UNITED STATES PATENT AND TRADEMARK OFFICE

APPLICATION NO.	FILING DATE	FIRST NAMED INVENTOR	ATTORNEY DOCKET NO.	CONFIRMATION NO.
10/527,395	10/12/2005	Dietmar Erich Bernhard Lilie	033794/290043	8634

Office Action Summary	Application No. 10/527,395	Applicant(s) LILIE, DIETMAR ERICH BERNHARD	
	Examiner CHRISTOPHER BOBISH	Art Unit 3746

DETAILED ACTION

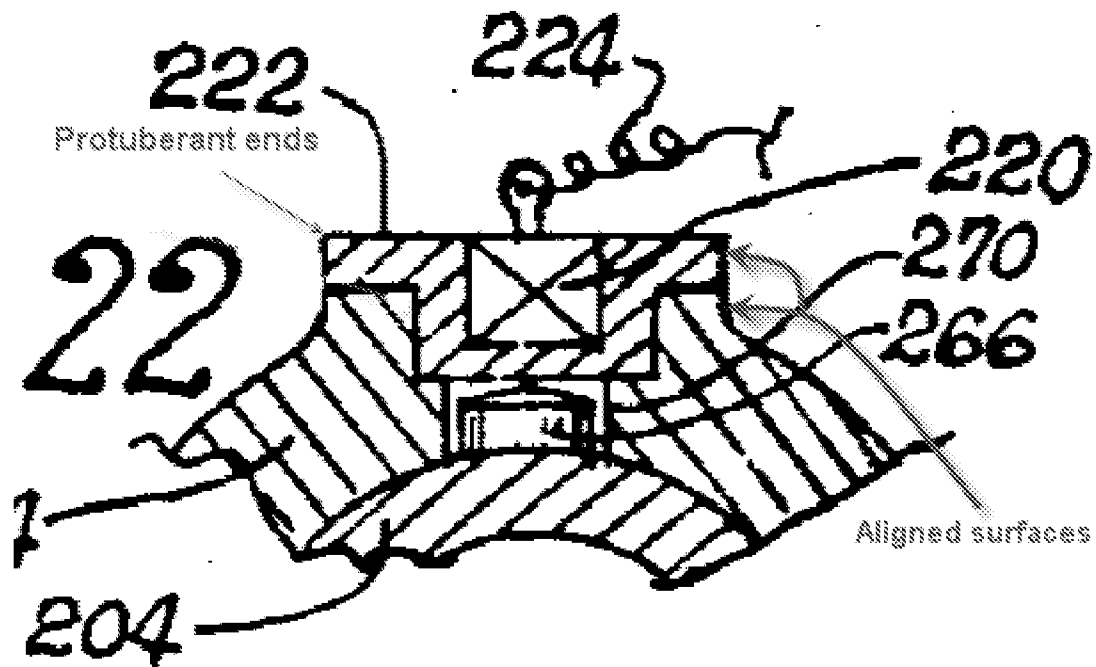
a protector **(19)** comprising at least one sensor cavity, **see FIG. 2 below as adapted by examiner**, for associating an inductive sensor;

a sensor being installed on a protector, **FIG. 2 shows a position sensing device (14, 15, 16, 17, 20), being fixed to the right against a protector (19);**

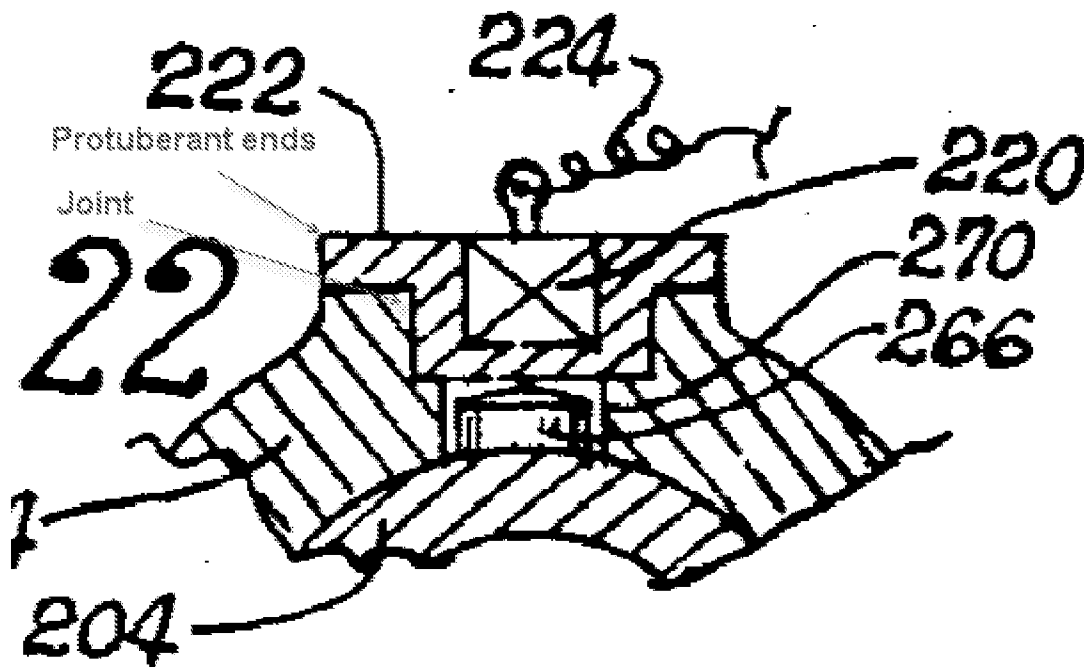
a sensor, **FIG. 22 (220) C. 12 Lines 22-23**, and a protector, **FIG. 22 (222) C. 12 Lines 23-25**, comprising protuberant ends, **as seen below in FIG. 22 as adapted by the examiner**, forming a joint;

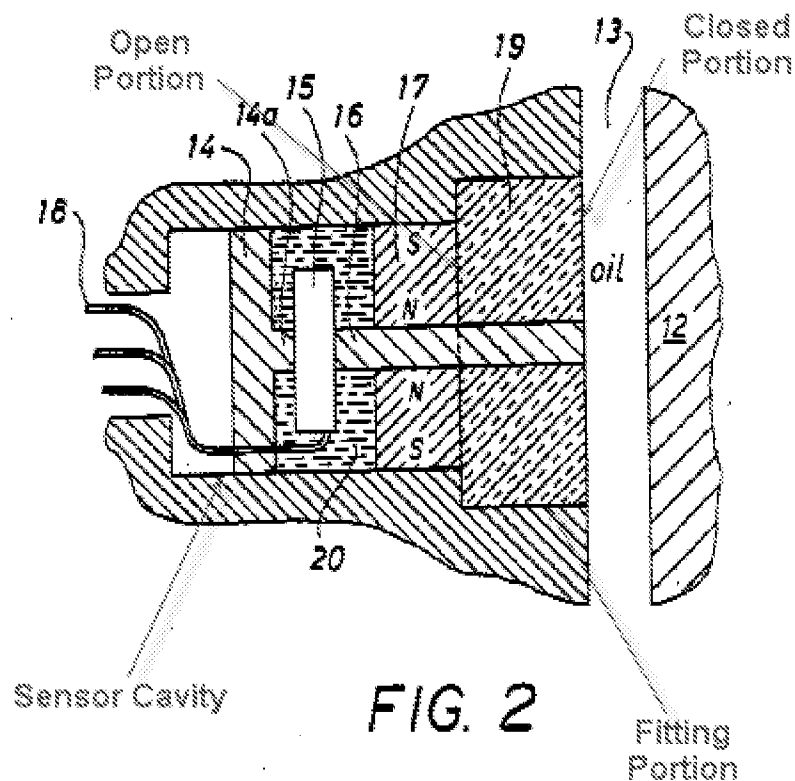
limitations from claim 20, wherein the edges of the sealing joint (**edges where the screw heads for a joint with the plate 21**) are place substantially over the protuberant ends (**the edges rest on top of the protuberant ends of protector 41, as can be seen at the top and bottom of the protector as shown in FIG. 3**);

FIG. 1

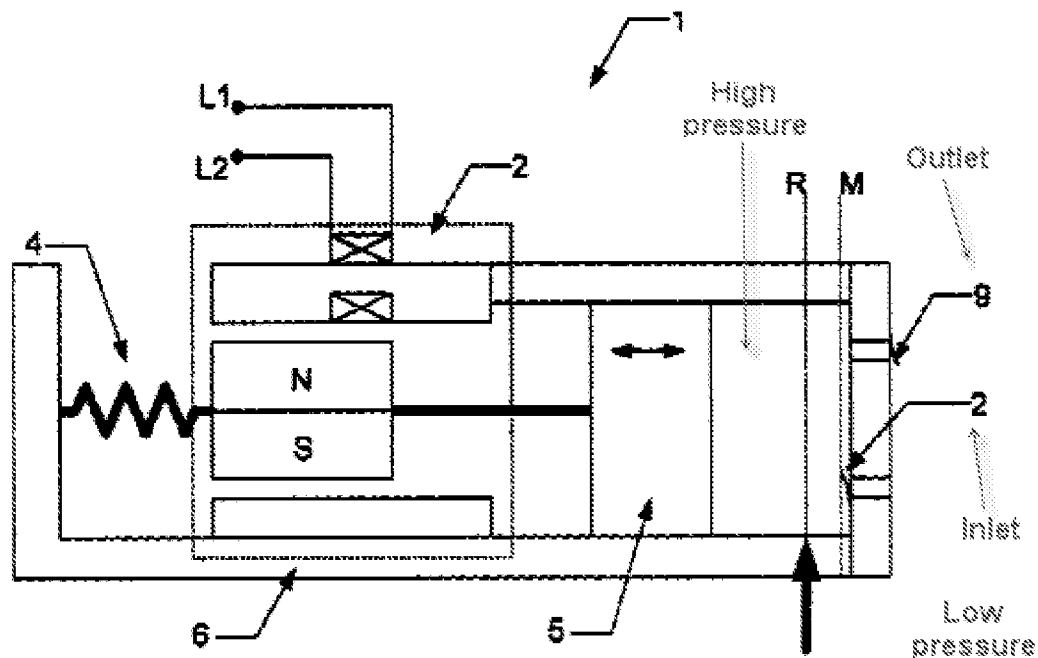
limitations from claim 5, a valve plate, **FIG. 1 (9) C. 4 Line 35**, comprises a suction valve associated with a low-pressure environment and a discharge valve associated with a high-pressure environment, **see FIG. 1 below as adapted by the examiner;**

When combined, the sensor and protector taught by Hvilsted and the valves taught by Schwarz will be associated with the same high and low pressure environments on either side of a plate (~9).
